Access Compliance Report

Public Rights-of-Way

Intersection ID: 6039	Main Street: DELLINGER_DR	Cross Street: MILHAVEN_LN	Location: NE
ADA ID: 017334E07DB7	Ramp Type: PerpDiag	Initial Pass/Fail: Pass	Overall Compliance: No
			Severity Score: 12.75

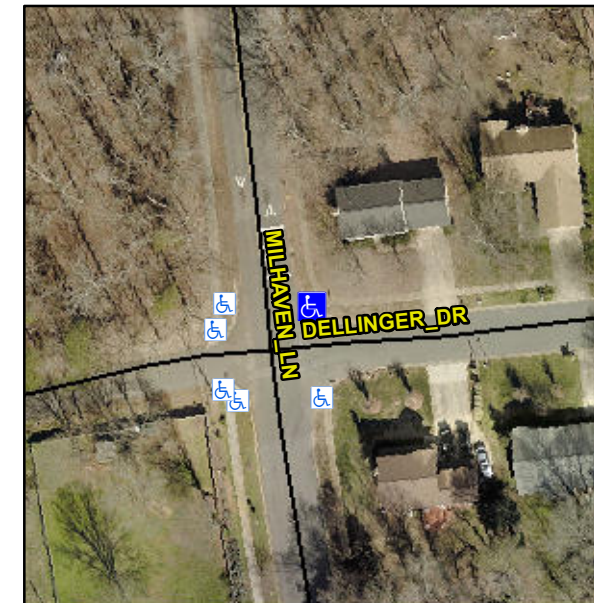
Not Found, R304.5.3, R304.2.2-Perp, R304.3.2-Para, R305.2, R302.7.2, R304.5.4

Compliance	Description	Data	Compliance	Description	Data
N/A	Ramp Length (in)	60.0	Yes	Ramp Slope (%)	5.5
Yes	Ramp Width (in)	48.0	No	Ramp XSlope (%)	3.7
N/A	Flare Type LT	Sloped	N/A	Flare Type RT	N/A
N/A	Flare Slope LT (%)	5.5	N/A	Flare Slope RT (%)	11.7
N/A	Flare Traversable LT?	No	N/A	Flare Traversable RT?	No
Yes	Landing Length (in)	48.0	Yes	DWS Provided?	Yes
Yes	Landing Width (in)	48.0	Yes	DWS Contrast?	Yes
No	Landing Slope (%)	4.9	Yes	DWS Length (in)	24.0
No	Landing X Slope (%)	8.2	Yes	DWS Full Width?	Yes
N/A	Landing Curb? (Y/N)	No	No	DWS Offset (in)	4.5
N/A	Shared Landing?	No			
Yes	Gutter Ponding?	No	No	Gutter Slope (%)	6.4
No	Gutter Lip Ht (in)	0.5	No	Gutter X Slope (%)	5.6
N/A	Painted X Walk1?	No	N/A	Painted X Walk2?	No
	X Walk 1 Direction	To W		X Walk 2 Direction	To S
N/A	X Walk 1 Width (in)	N/A	N/A	X Walk 2 Width (in)	N/A
	X Walk 1 Slope (%)	0.9		X Walk 2 Slope (%)	6.5
	X Walk 1 X Slope (%)	5.9		X Walk 2 X Slope (%)	1.9

Remove & Replace Curb Ramp With Two New Directional Ramps or Equivalent. Remove & Replace Gutter.
